Access Compliance Report

Public Rights-of-Way

Intersection ID: 48392	Main Street: ALVIN_WOODS_DR	Cross Street: JOE_MORRISON_LN	Location:	SW
ADA ID: F17E93750146	Ramp Type: PerpDiag	Initial Pass/Fail: Fail	Overall Compliance: No	Severity Score: 10

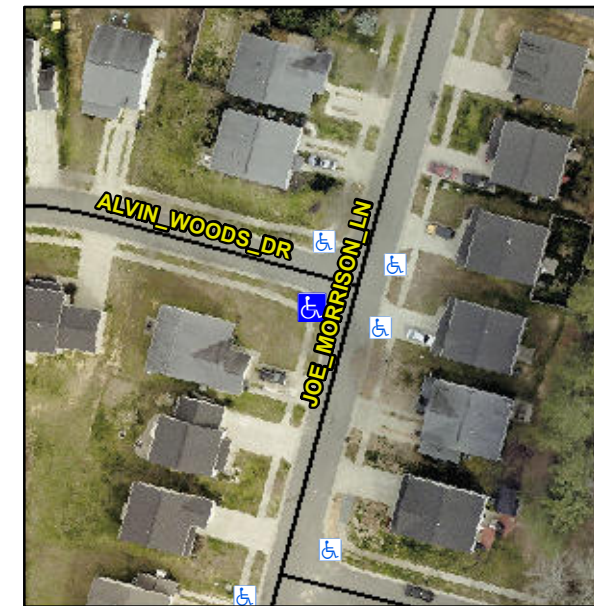
Not Found, R304.5.1, R304.5.3

Compliance	Description	Data	Compliance	Description	Data
N/A	Ramp Length (in)	73.0	Yes	Ramp Slope (%)	5.2
No	Ramp Width (in)	43.0	No	Ramp XSlope (%)	2.4
N/A	Flare Type LT	N/A	N/A	Flare Type RT	N/A
N/A	Flare Slope LT (%)	N/A	N/A	Flare Slope RT (%)	N/A
N/A	Flare Traversable LT?	N/A	N/A	Flare Traversable RT?	N/A
N/A	Landing Length (in)	N/A	N/A	DWS Provided?	N/A
N/A	Landing Width (in)	N/A	N/A	DWS Contrast?	N/A
N/A	Landing Slope (%)	N/A	N/A	DWS Length (in)	N/A
N/A	Landing X Slope (%)	N/A	N/A	DWS Full Width?	N/A
N/A	Landing Curb? (Y/N)	N/A	N/A	DWS Offset (in)	N/A
N/A	Shared Landing?	N/A			
N/A	Gutter Ponding?	N/A	N/A	Gutter Slope (%)	N/A
N/A	Gutter Lip Ht (in)	N/A	N/A	Gutter X Slope (%)	N/A
N/A	Painted X Walk1?	No	N/A	Painted X Walk2?	No
	X Walk 1 Direction	To E		X Walk 2 Direction	To N
N/A	X Walk 1 Width (in)	N/A	N/A	X Walk 2 Width (in)	N/A
	X Walk 1 Slope (%)	4.1		X Walk 2 Slope (%)	3.5
	X Walk 1 X Slope (%)	0.9		X Walk 2 X Slope (%)	4.9

Remove & Replace Curb Ramp With Two New Directional Ramps or Equivalent.
